OPEN
Compute Project

OCP NIC 3.0 Design Specification

Version 0.62

Author: OCP Server Workgroup, OCP NIC subgroup

Figure 35: Port and LED Ordering – Example Small Card Link/Activity and Speed LED Placement

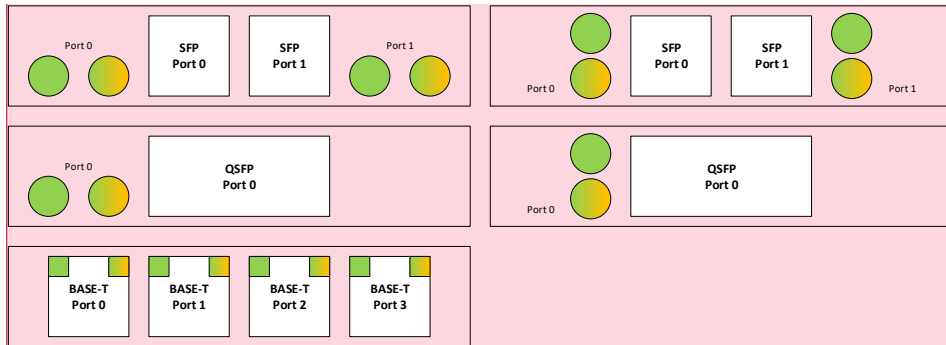
Commented [JN6]: Suggest to add illustration of PCB in order to show this is "up side up"

Figure 59: 168-pin Base Board Primary Connector – Right Angle

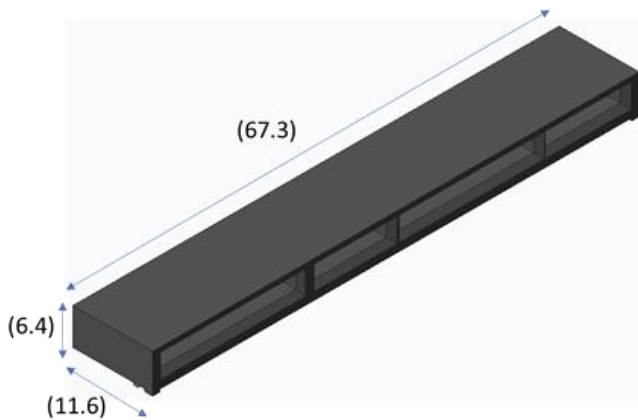
Commented [NT16]: All connector drawings + dimensions need to be updated .

Figure 71: Example Power Supply Topology

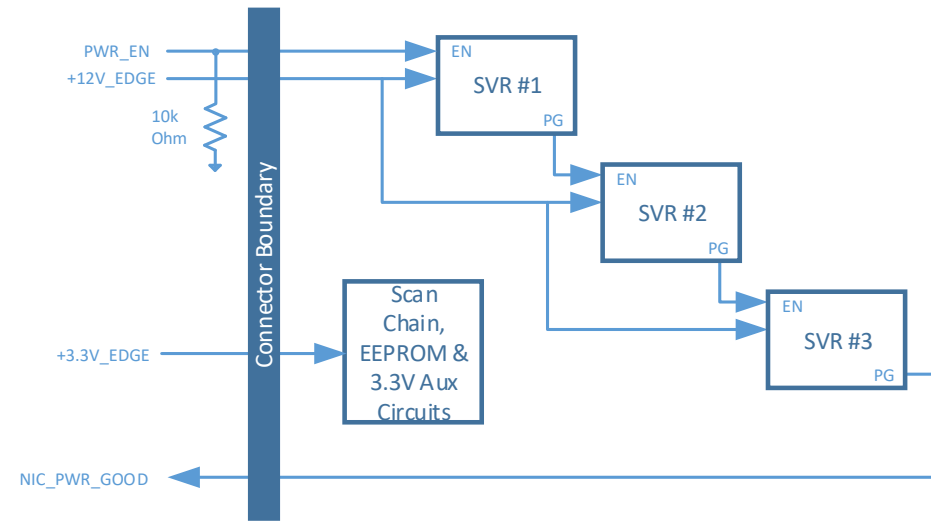
Commented [TN21]: Change PWRDIS to PWR_EN global replace.
Remove inverter.
Edit text regarding polarity to match.
